City of Ryde Local Planning Panel Meeting No. 4/20

- 1 2 COOINDA CLOSE, MARSFIELD. CONSTRUCTION OF A TWO STOREY BOARDING HOUSE COMPRISING 8 X 2 BED BOARDING ROOMS AND A DOUBLE GARAGE. THE PROPOSAL PROVIDES 4 CAR PARKING SPACES, 2 MOTOR CYCLE PARKING SPACES AND 4 BICYCLE PARKING SPACES - LDA2019/0304**

City of Ryde Local Planning Panel Report

Figure 14: Proposed stormwater and on site detention plan

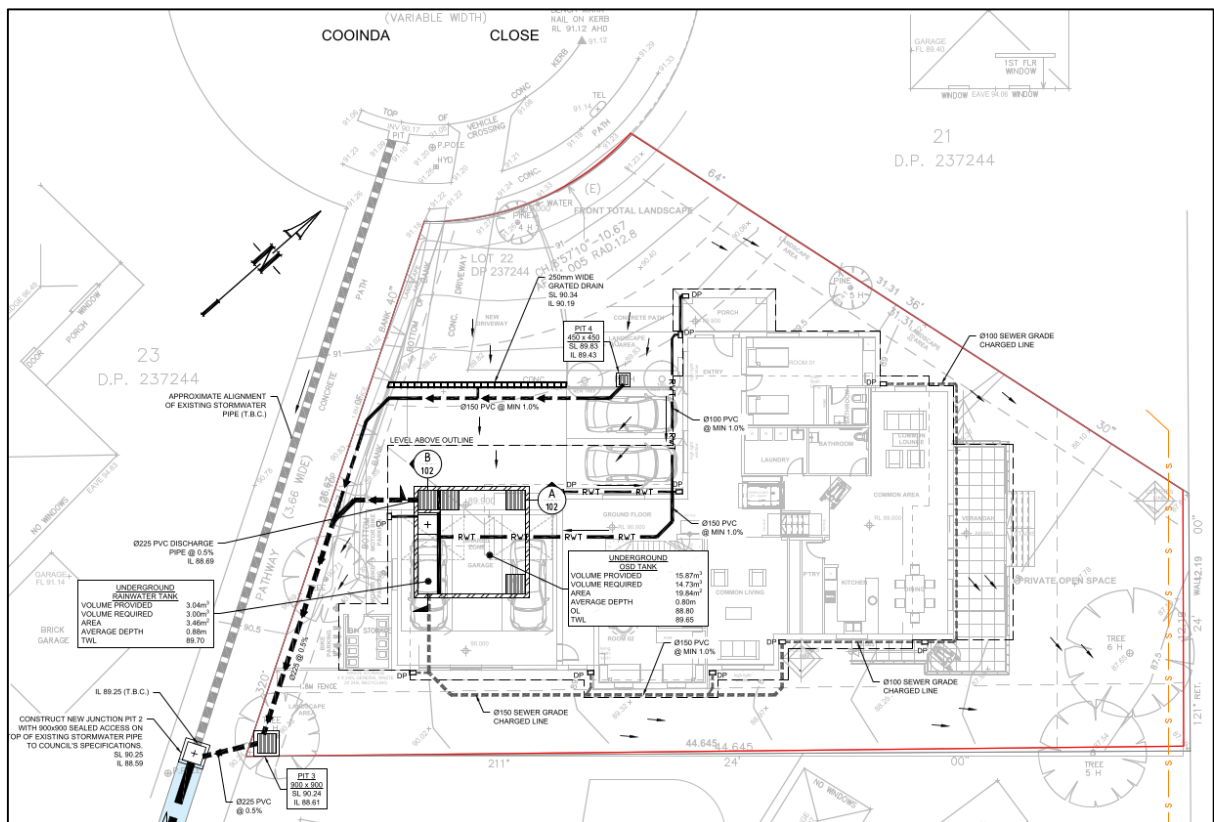
The proposed stormwater management plan requires the construction of a new junction pit within the pedestrian pathway. The proposed works will directly impact Council stormwater drainage assets and insufficient information has been provided to determine if the design is acceptable. Based on the above, it cannot be said that the proposal satisfies the requirements of Clause 6.4 and therefore the proposal is recommended for refusal.

Comment: The amended proposal incorporates underground on site detention and drainage connection to an existing Council drain beneath the pedestrian pathway adjacent to the site. Council's Stormwater and Catchments team have advised that proposal has provided insufficient information and a proper assessment of the stormwater impacts on Council assets and surrounding properties cannot be completed. This forms part of the reasons for refusal.

Figure 21: Front setbacks of site and surrounding properties.

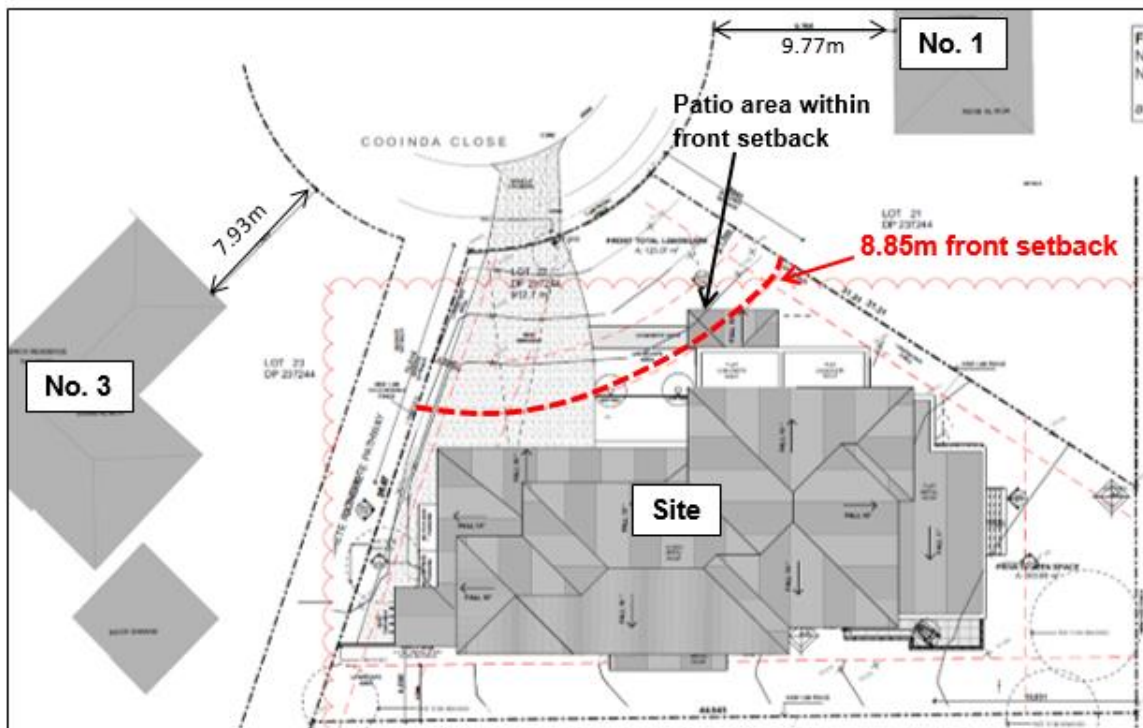
The front setback for the proposed development has taken into consideration the setback of immediately adjoining properties within the street, particularly at the end of the cul-de-sac (refer Figure 21 below). The existing front setback of No. 1 Cooinda Close is 9.77 metres and No. 3 Cooinda Close has a front setback of 7.93 metres. As

surrounding properties have various front setbacks to ensure consistent building setbacks along the street, it is considered appropriate for the front setback of the site to be an average of the two immediately adjoining properties, measured at 8.85 metres.

While the front setback of 8.85 metres provides an appropriate transition between the adjoining properties at the end of the cul-de-sac, the projection of the patio into the front setback (approximately 6.84 metres from the front boundary) is out of character with the setting of surrounding dwellings and is not appropriate.

Figure 24: Proposed south-eastern setback at ground floor

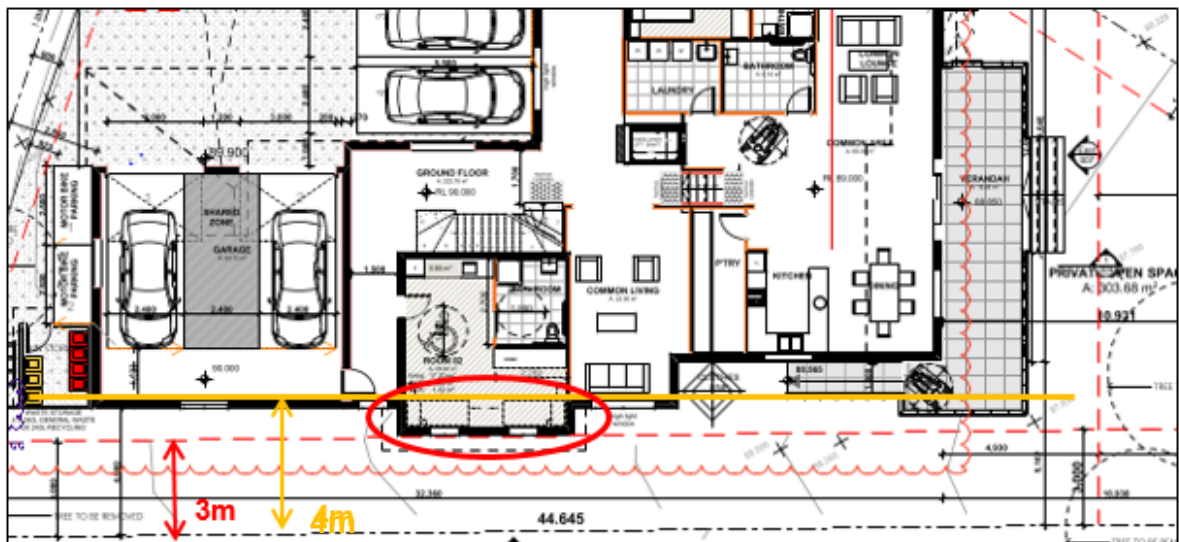
The proposed setback of the south-eastern boundary achieves a minimum of 4 metres except the ground floor boarding room which is setback 3 metres from the boundary (see Figure 24 below). The proposed 3 metre setback is not supported as two window openings to the boarding room will result in poor privacy and amenity for occupants and the adjoining property. In particular, the proposal does not provide landscape screening along side or rear boundaries and will result in adverse visual and acoustic impacts on occupants and adjoining properties.

Comment: The proposal does not provide a sufficient setback to the south-eastern rear boundary to minimise visual and acoustic privacy impacts on adjoining properties. The internal layout and window configurations to the ground floor provides poor amenity to occupants of the boarding house and does not mitigate amenity impacts on adjoining properties. The setting and design of the boarding house will have adverse impacts on the amenity of surrounding properties and is not supported.

Figure 25: Tree location plan

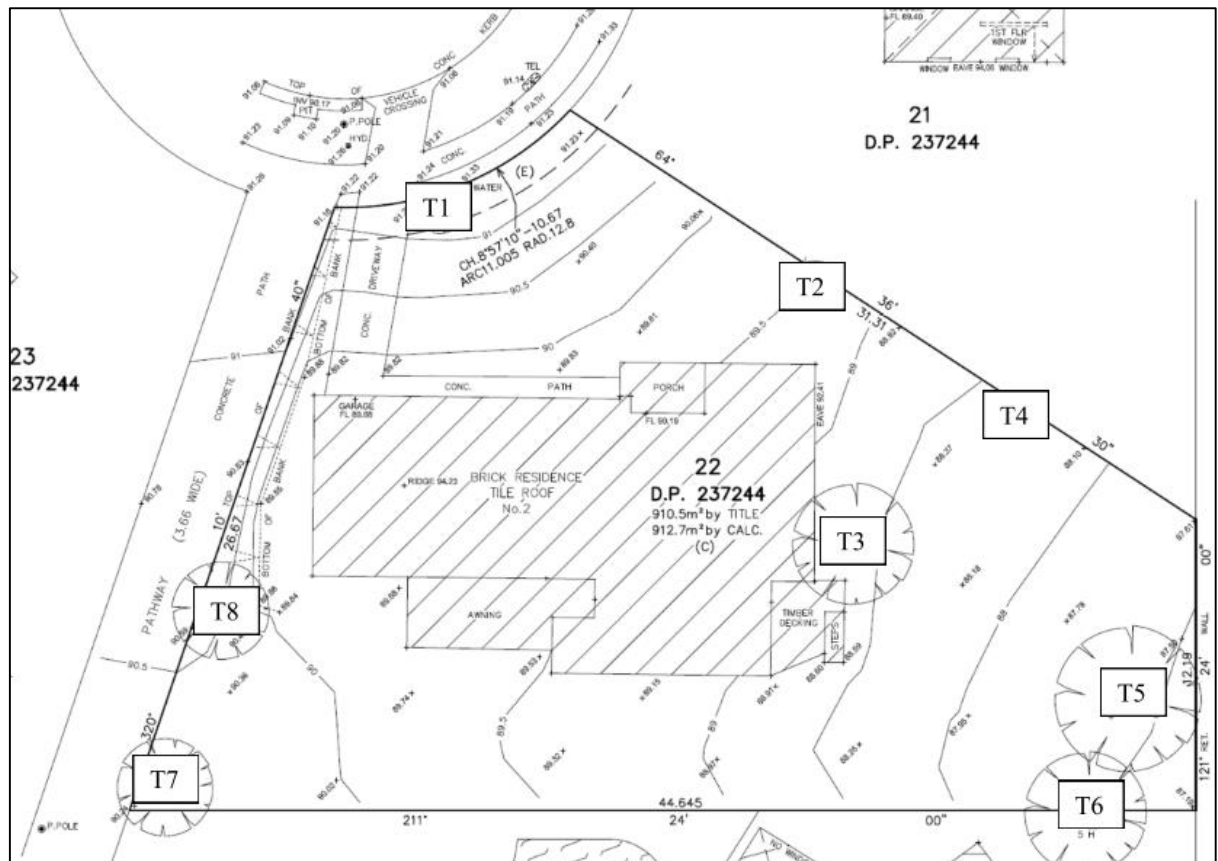
- Tree 2 is to be retained but is not shown on the landscape plan
- Tree 3 could be transplanted but is not shown on the landscape plan
- Tree 4 is to be removed but is not shown on the landscape plan
- Tree 5 is to be retained but is shown to be removed on the landscape plan
- Tree 6 is located on the adjacent property and is to be retained but is shown as being removed on the landscape plan
- Tree 7 is to be retained but is shown to be removed on the landscape plan

4	Cinnamomum camphora Camphor Laurel	Remove Weed tree <i>Not shown on amended Landscape Plan</i>	Agree
5	Lagerstroemia indica Crape Myrtle	Retain <i>Shown to be removed on amended Landscape Plan</i>	Retain <i>Not affected by development</i>
6	Glochidion ferdinandl Cheese tree	Retain On adjoining property <i>Shown to be removed on amended Landscape Plan</i>	Retain <i>Not affected by development, and survey shows it to be on the adjoining property.</i>
7	Magnolia x soulangeana Chinese Magnolia	Retain <i>Shown to be removed on amended Landscape Plan</i>	Remove <i>Encroached by Stormwater pipes.</i>
8	Tibouchina urvilleana Lassiandra	Remove In development area	Agree
